Product Change Notification / JAON-23VTYQ024

CCB 4611 Final Notice: Qualification of MMT as an additional assembly site for selected Microsemi PD69101ILQ-TR and PD69101ILQ-13155TR catalog part numbers (CPN) available in 24L VQFN (4x5x1.0mm) package.

CCB 4611
Pre and Post Change Summary
PCN#: JAON-23VTYQ024

PCN# JAON-23VTYQ024

NSEB LF

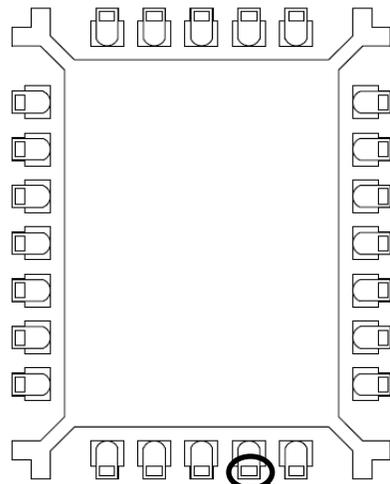
Lead lock hole

Lead frame material	EFTEC-64T
Lead frame Paddle size	114x154 mils
Lead-lock (Locking Hole)	Yes

UNIC LF

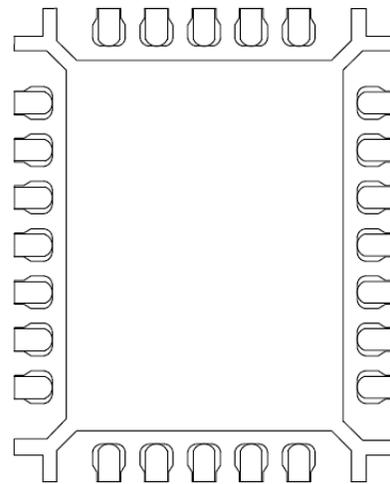
Lead frame material	A194
Lead frame Paddle size	114x154 mils
Lead-lock (Locking Hole)	No

MMT LF

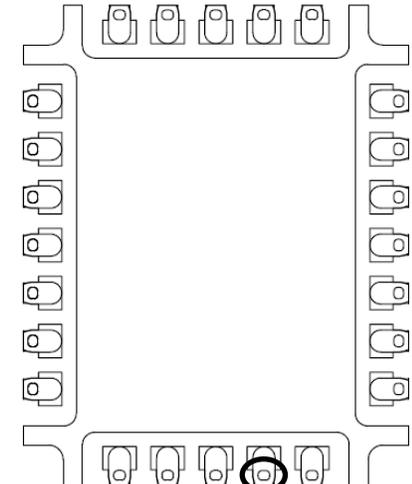
Lead lock hole

Lead frame material	A194
Lead frame Paddle size	114x154 mils
Lead-lock (Locking Hole)	Yes

Note: Mold compound material fills the leadlock hole, which provides improved protection against moisture penetration along the edge of the leads (pins) of the package.
